Product / Process Change Notification (PCN)

<p>PCN #: PCN_IndCMB_20201228</p> <p>Affected Series: WE-CMB-Series 744821xxx 744822xxx 744823xxx 744824xxx 744825xxx</p> <p>PCN Date: September 28, 2020</p> <p>Effective Date: December 28, 2020</p>	<p>Change Category:</p> <p><input type="checkbox"/> Equipment / Location <input checked="" type="checkbox"/> General Data <input checked="" type="checkbox"/> Material <input checked="" type="checkbox"/> Process <input type="checkbox"/> Product Design <input type="checkbox"/> Shipping / Packaging <input type="checkbox"/> Supplier <input type="checkbox"/> Software</p>
<p>Contact: Product Management</p> <p>Phone: +49 (0) 7942 - 945 5001</p> <p>Fax: +49 (0) 7942 - 945 5179</p> <p>E-Mail: pcn.eisos@we-online.com</p>	<p>Data Sheet Change:</p> <p><input checked="" type="checkbox"/> Yes <input type="checkbox"/> No</p> <p>Attachment:</p> <p><input type="checkbox"/> Yes <input checked="" type="checkbox"/> No</p>

Spacer drawing for CMB Series 744821xxx

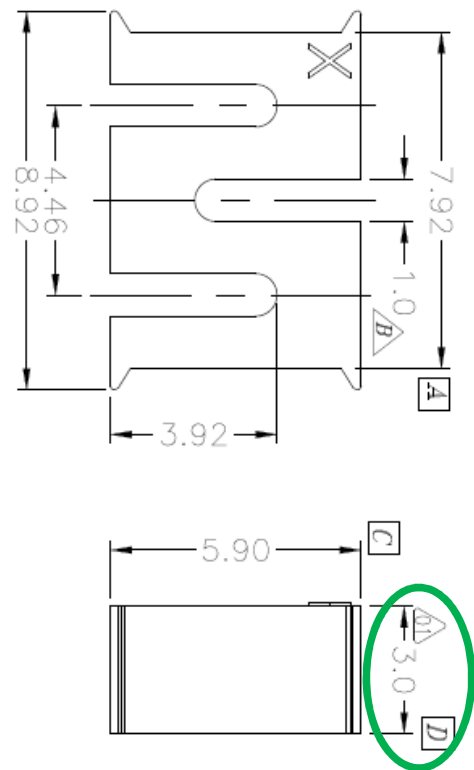
To assure assembling processability, Würth Elektronik will change the spacer thickness from currently 2 mm to 3 mm. For detailed information, refer to drawings on next page. As example the spacer drawing for CMB Series 744821xxx.

Picture 1

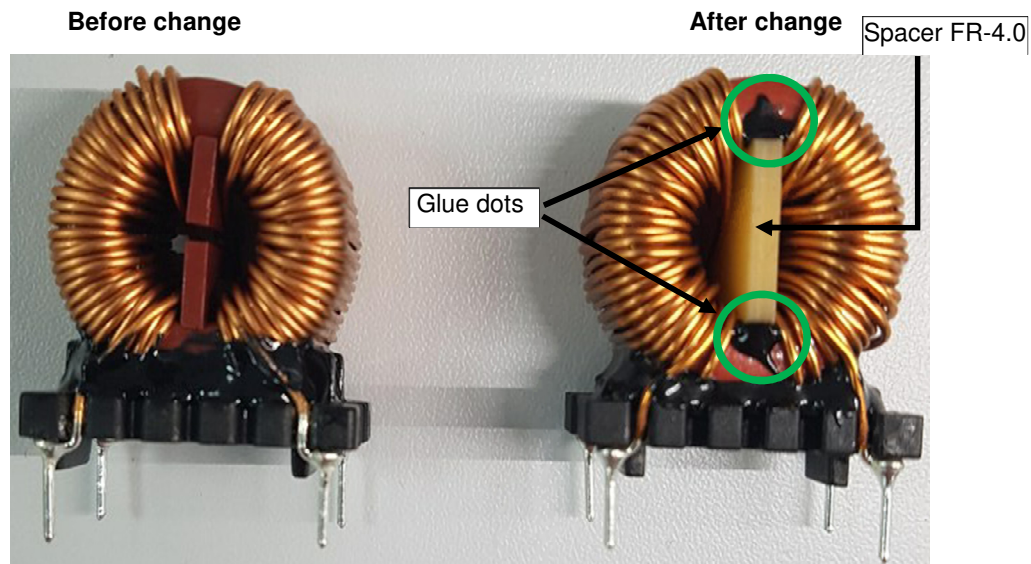
For some articles it was not possible to implement this change as the winding distance between both windings is insufficient. In this case we will implement new spacer based on FR4- Material, with material thickness 2,5 mm and UL-File number E123995. We also will add 4 glue dots on the spacer to achieve the 3 mm minimal creepage distance between windings. Affected articles are listed on **table 1** and shown under **picture 1**.
